Model 2450 System SourceMeter®

Version v1.6.4c Firmware Release Notes

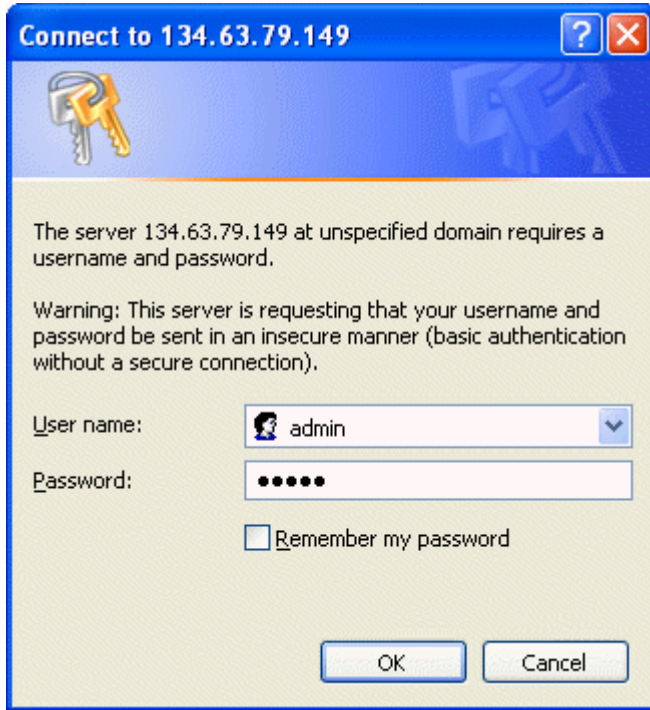
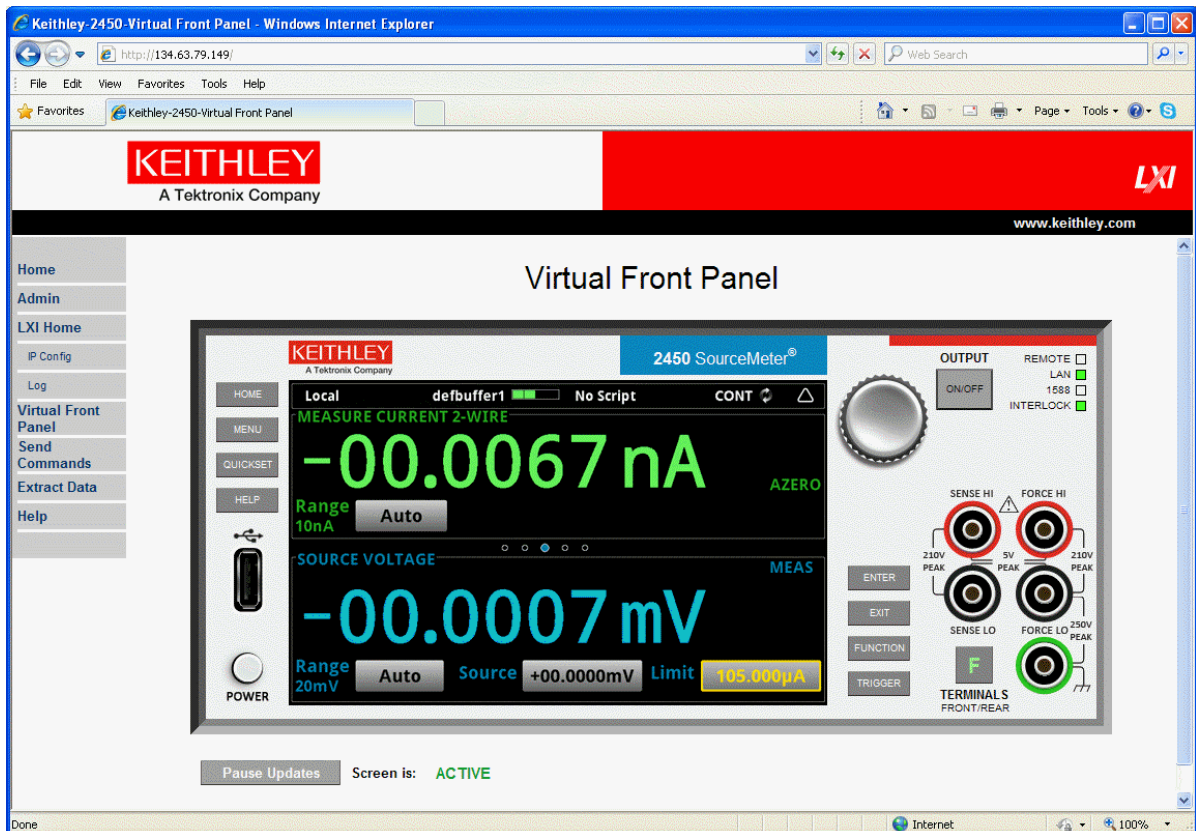
Implement new Virtual Front Panel capability.

To access the new Virtual Front Panel, access the 2450 through Ethernet using your favorite Internet browser.

When asked for a Username and Password: enter the Username and Password for that particular 2450. The default Username is `admin` and the default Password is `admin`.

An example of the 2450 Virtual Front Panel is shown below. Users can use their mouse from a standard PC to control the instrument. Users can also use touch screens from most touch screen devices that can access the 2450 IP address.

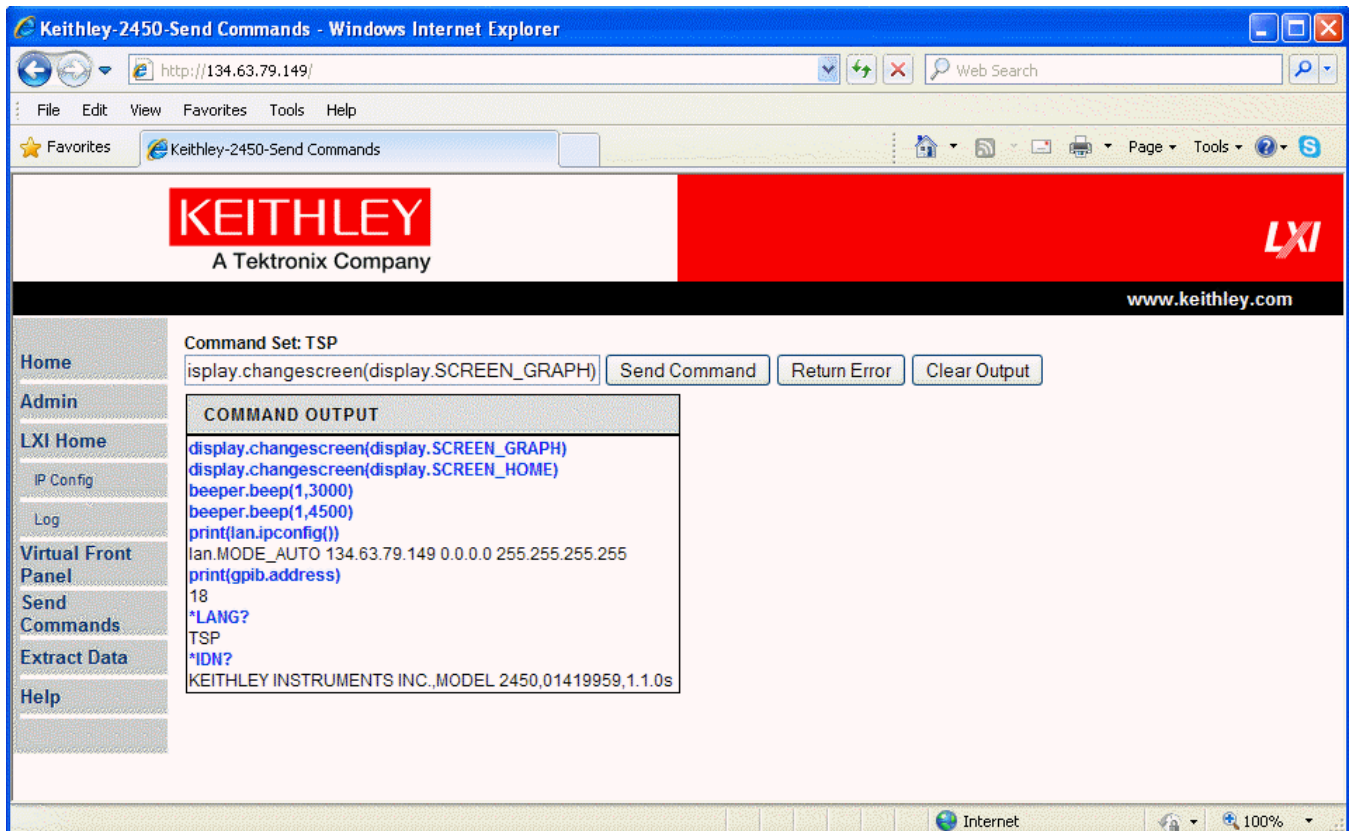
The behavior of the *LANG? command on the 2450 has been changed as follows.

Sending the query *LANG? over a non-controlling interface will no longer change the interface control of the unit. For example, if the unit is under local control, then sending the *LANG? over Telnet, USB, or GPIB will leave the unit under local control. This was done in order for KickStart (or any other remote control software) to query connected/accessible instruments without resetting them or changing or disturbing the current trigger model.

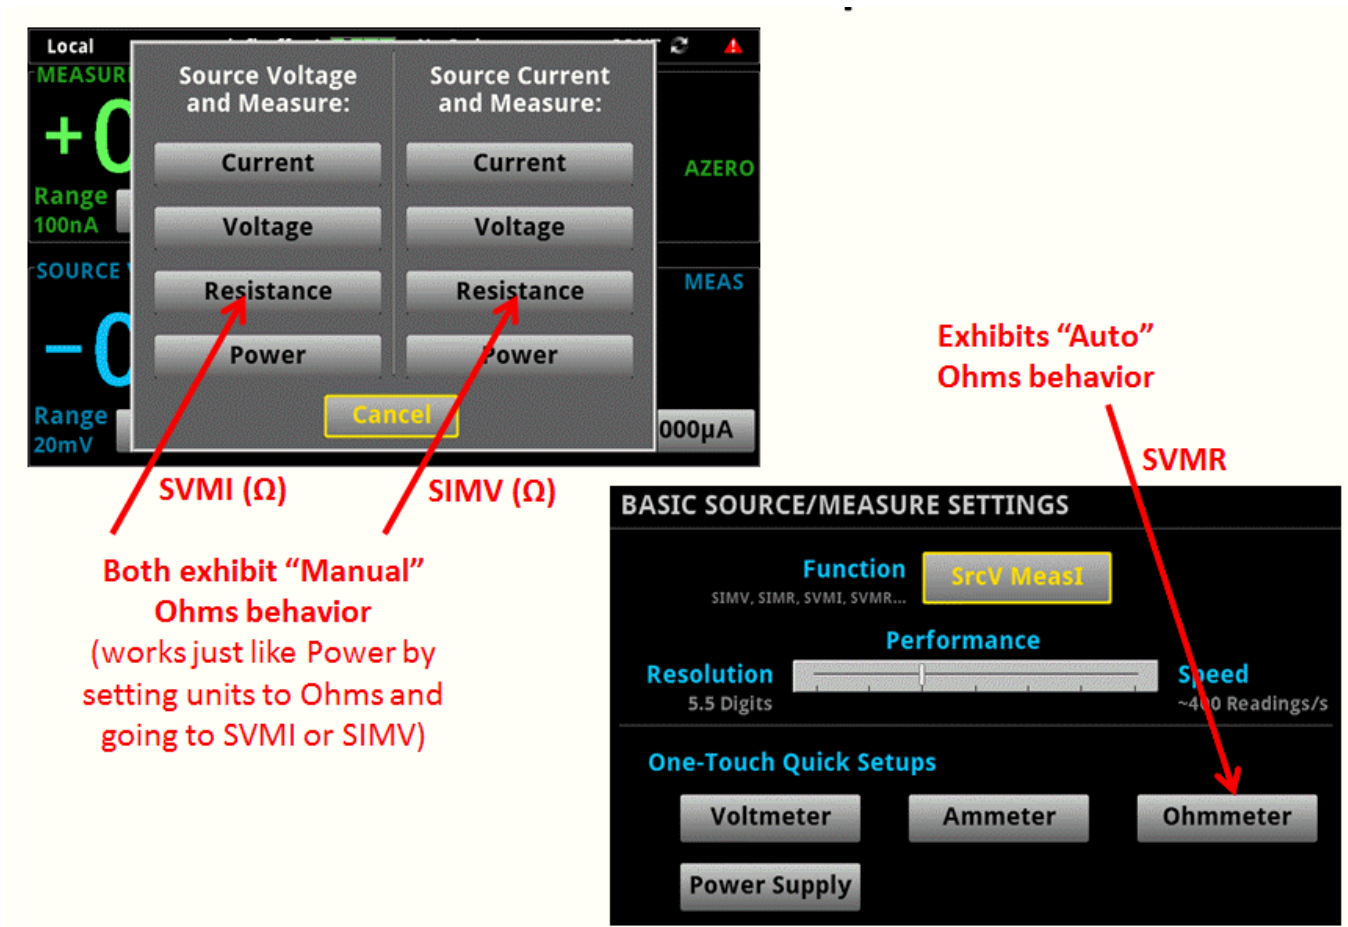
- `smu.measure.unit = smu.UNIT_OHM`
 - ii. “Auto Ohms” → Measures resistance by sourcing current, measuring voltage, and calculating the resistance reading. In this case, the source current and source limit are automatically calculated and set.

- `smu.measure.func = smu.FUNC_RESISTANCE`
- g. New SCPI Command Usage:
- i. "Manual Ohms" (see definition above)
 - `SOURCE:FUNC VOLTage`
 - `[SENSE[1]]:FUNC "CURRENT"`
 - `[SENSE[1]]:CURRENT:UNIT OHM`OR
 - `SOURCE:FUNC CURRENT`
 - `[SENSE[1]]:FUNC "VOLTage"`
 - `[SENSE[1]]:VOLTage:UNIT OHM`
 - ii. "Auto Ohms" (see definition above)
 - `[SENSE[1]]:FUNC "RESistance"`
- h. Front panel user interface setting of Manual vs. Auto Ohms measurements
- <see the following figure for details>
